Supporting materials for comments 87 and 88

Comment #87

Comment #88

Response time

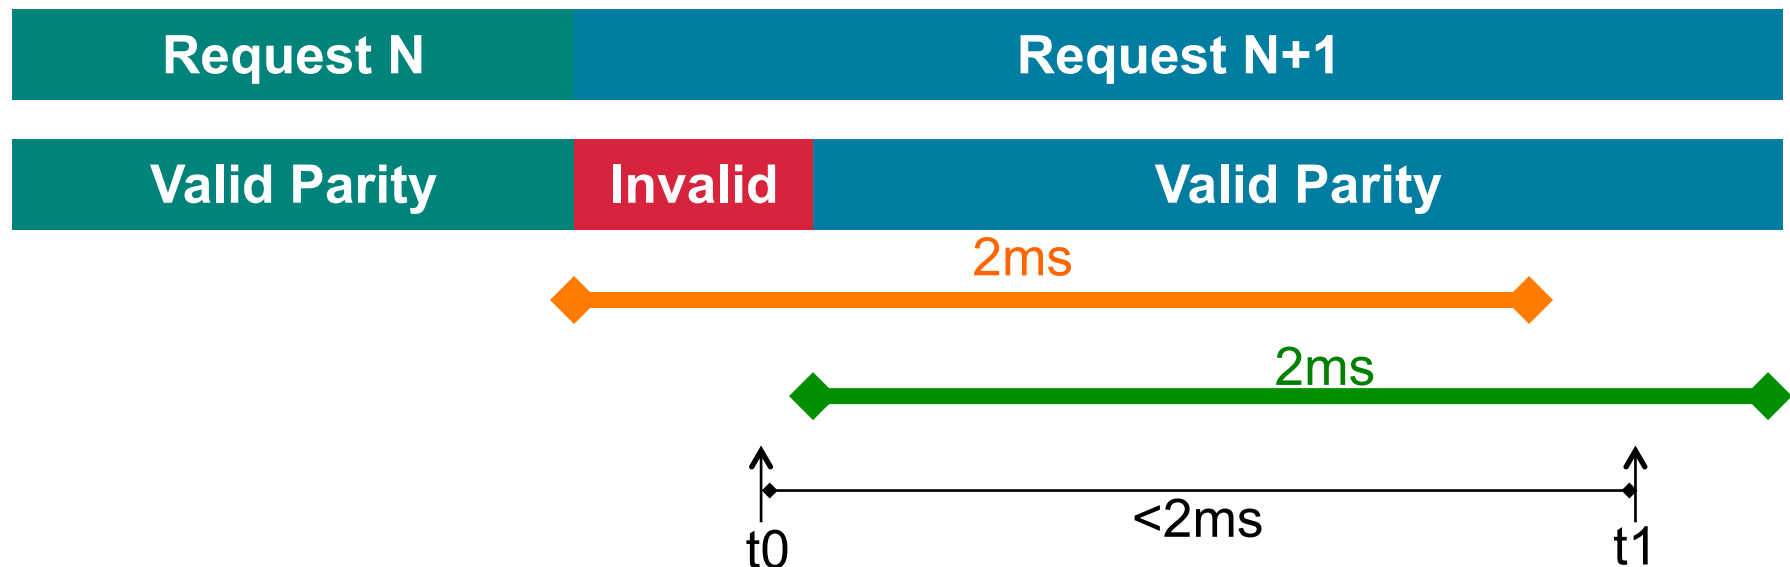
- But the parity bit is sent in the Status Field.

Example issue

- Design is checking the parity bit for validity, at time t_0 it's invalid so it doesn't process Request N+1 until t_1 . The interval between t_1 and t_2 time is less than required 2ms.
- However if 2ms window begins when Control field update is received, then it would violate the response time. If the 2ms window starts when both Control and Status field are valid, then it'd be compliant.

- Follow suggested remedy
 - Add in the parity bit to qualify the start of the 2ms window
- Alternate approach would be
 - Change the parity bit to be ignored on receipt. (convert may be to is)

Clause 72

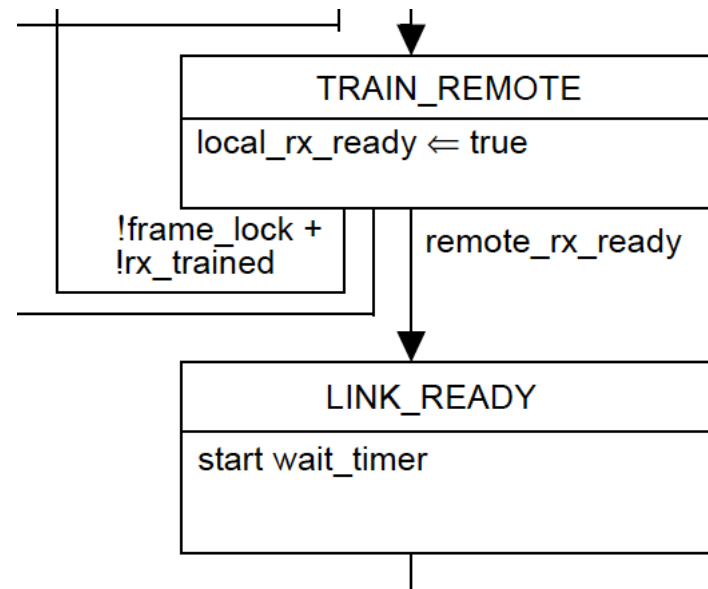
- In all previous generation PMDs we wait on getting 3 frames from the remote end indicating it's "done" before beginning the shutdown process

What does the 3x do?

- During a Link Train process you will see one side end first (begin sending receiver ready) and it sits there waiting for the other end to complete.
- The three consecutive receptions causes
 - A) Prevents a single mis-decode of the status from causing the “already done” side to begin shutdown early
 - B) Allows for the “slower” side time to enter/transition through the same state

- Adding the 3x qualification to remote_rx_rdy and remote_tf_lock provides a more tolerant receiver operation.
